**Remediation System Evaluation (RSE)  
Tutu Wellfield Superfund Site**

**St. Thomas, U.S. Virgin Islands**

Report of the Remediation System Evaluation  
Site Visit Conducted at the Tutu Wellfield Superfund Site on  
February 8, 2011

Final Report

Figure 2-1  
Site-Wide Groundwater Elevations and CVOC Concentrations  
April 2010 RA Progress Report  
Tutu Wellfield Site, St Thomas, USVI

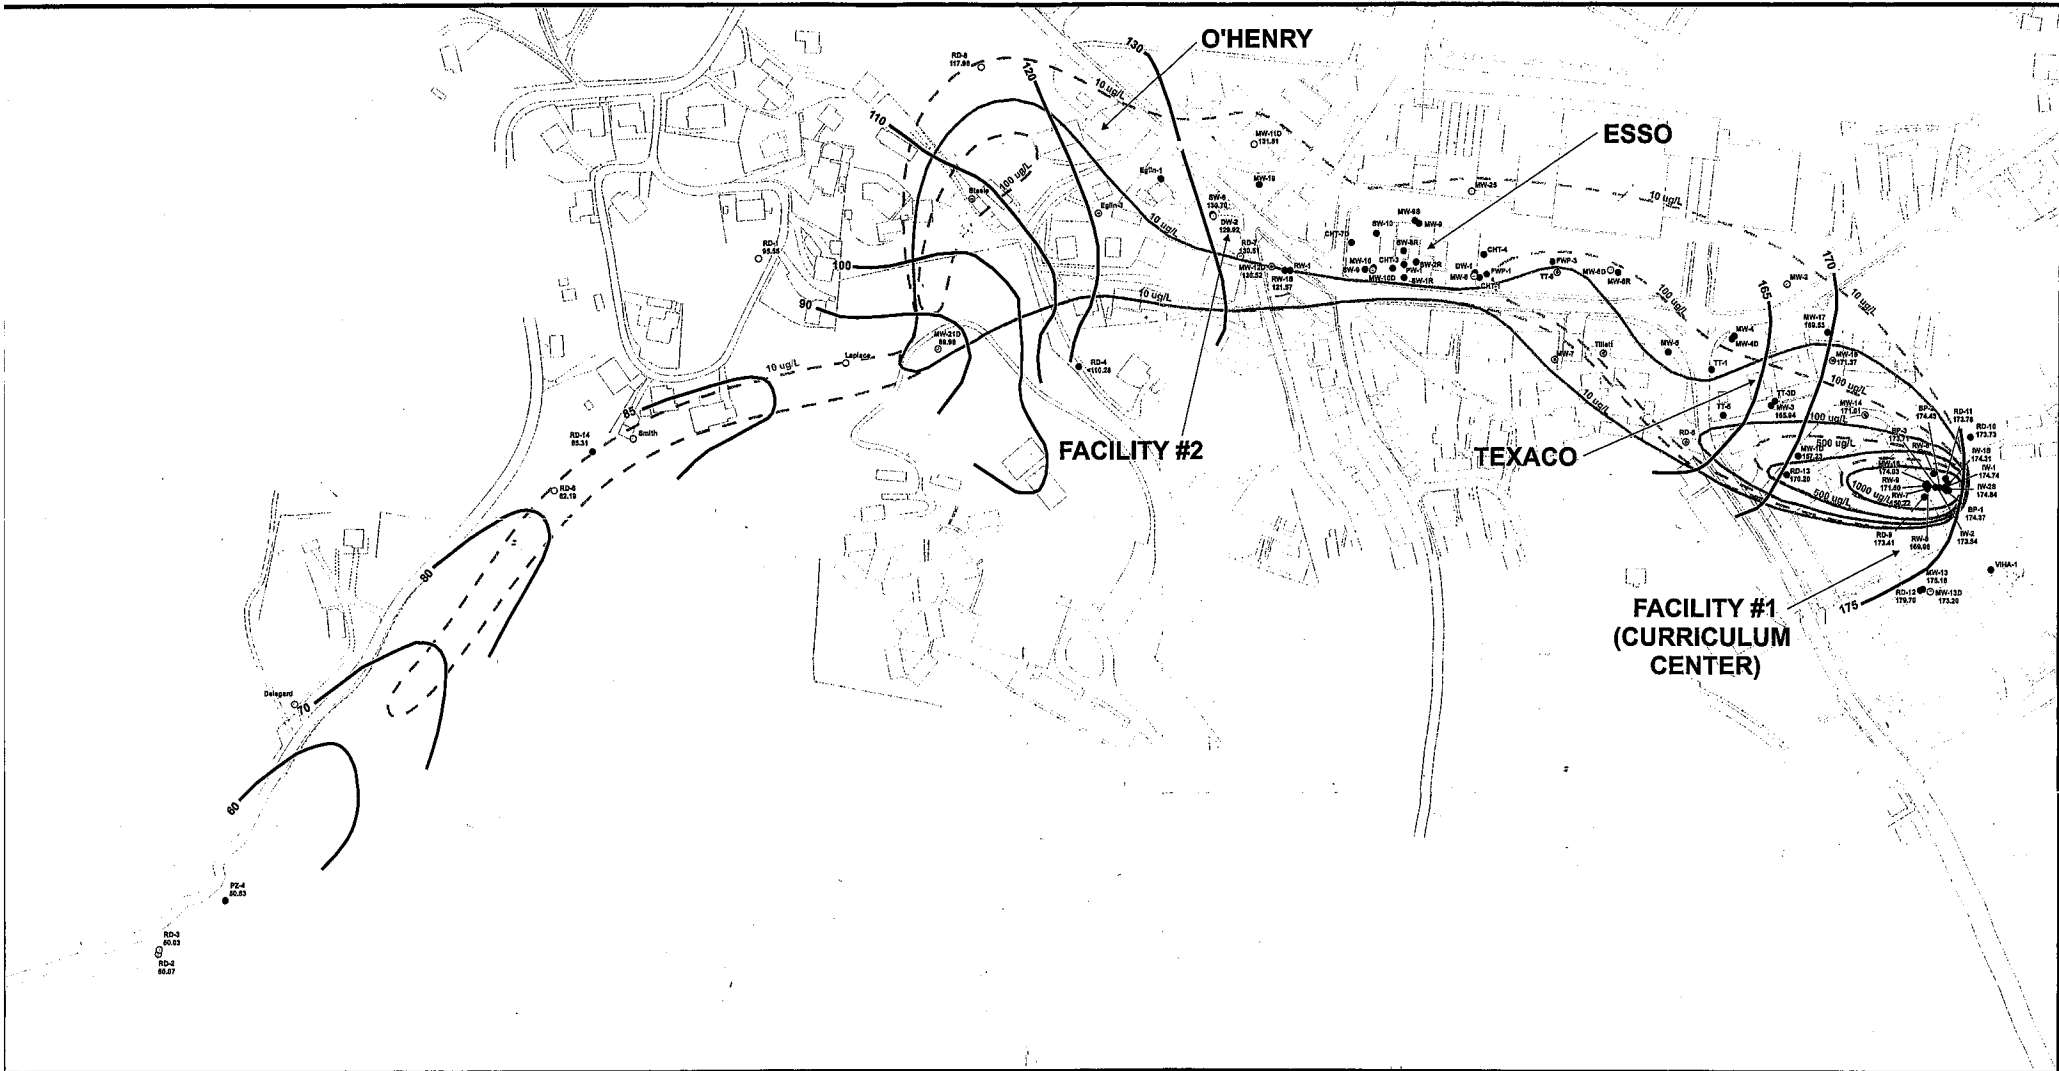
The first figure in Appendix A shows the interpreted potentiometric surface in and around the CVOC plume(s) associated with the Tutu Wellfield Superfund Site in April 2010. The northern and upgradient end of the plume is at the Curriculum Center near GWTF #1. In this area, the potentiometric contours (particularly at 175 feet above mean sea level) are interpreted by the contractor (CDM) to bend in a way that suggests converging flow (toward the extraction wells). However, the exact location and shape of these contours is not entirely supported by the water-level data posted on the map (two of the four water levels posted upgradient of the 175-ft contour are less than 175 ft). It is likely that the shape of the head contours reflects the conceptual model of groundwater flow converging from the east and west into the bedrock valley that controls the migration of the regional CVOC plume. In any case, the contours as drawn suggest that the capture width from extraction wells RW-7 and RW-9 would be approximately 75 ft or less. However, the 100- $\mu\text{g/L}$  CVOC plume is approximately 200 ft wide in this area. Water-level data at approximately twelve wells in very close proximity to the extraction wells (within approximately 100 ft of RW-7) could probably be analyzed in further detail on a zoomed-in map to better define the shape of potentiometric contours and capture zone. For such an analysis, measured water-levels at active extraction wells should not be used due to well losses. However, this type of analysis could be complicated by vertical hydraulic gradients. It does not appear that such an analysis would indicate a capture zone width greater than approximately 75 ft and certainly it would be much less than 200 ft.

For purposes of this evaluation, it is assumed that the target capture zone is the CVOC plume greater than 100 µg/L (total) at the Curriculum Center. It is assumed that lower concentrations of CVOCs would be remediated by natural attenuation or captured in the downgradient system at GWTF #2. The width ( $w$ ) of the target capture zone is approximately 200 ft as measured from the figure in Appendix A.

Using this same figure, the hydraulic gradient ( $J$ ) is estimated to be 0.02 (10 ft head drop over approximately 500 ft distance) on average at the Curriculum Center. However, the gradient apparently increases toward the south and is somewhat uncertain. Therefore, calculations were made using a reasonable range of hydraulic gradient between 0.015 (5 ft drop over 330 ft) and 0.025 (5 ft drop over 200 ft).

Review of the map in Appendix A indicates that there are insufficient water-level data in the vicinity of RW-1S from which to draw a potentiometric surface of sufficient detail to evaluate plume capture near GWTF #2.

As indicated in Section 4.2.1, the interpreted capture zone associated with GWTF #1 is small relative to the size of the high-concentration portion of the plume (e.g., greater than 100 µg/L CVOCs). RW-7 is too far upgradient to effectively contain the Curriculum Center source area. A new containment system including a line of wells perpendicular to the flow direction screened through the shallow and deep zones near RD-13 (300 ft downgradient) should be considered. The plant is designed for up to 60 gpm so additional flow can be taken.

To attain 50 gpm extraction, approximately four new extraction wells are likely to be needed, each capable of pumping up to approximately 18 gpm (similar to the extraction rate at existing well RW-7). This will allow 50 gpm to be attained when one well is off line for maintenance. The number and spacing of wells to add should be evaluated based on: (1) review of the available geologic information and the currently available hydrogeologic data (e.g., boring logs for existing/past nearby monitoring and pilot scale treatment wells and historical water level data under operating conditions); and (2) field testing (e.g. specific-capacity testing) of the new wells during installation. The new extraction well system should be designed to attain capture of the high-concentration portion of the CVOC plume; this will also address deep contamination that slowly partitions upward into the capture zone of the extraction system.
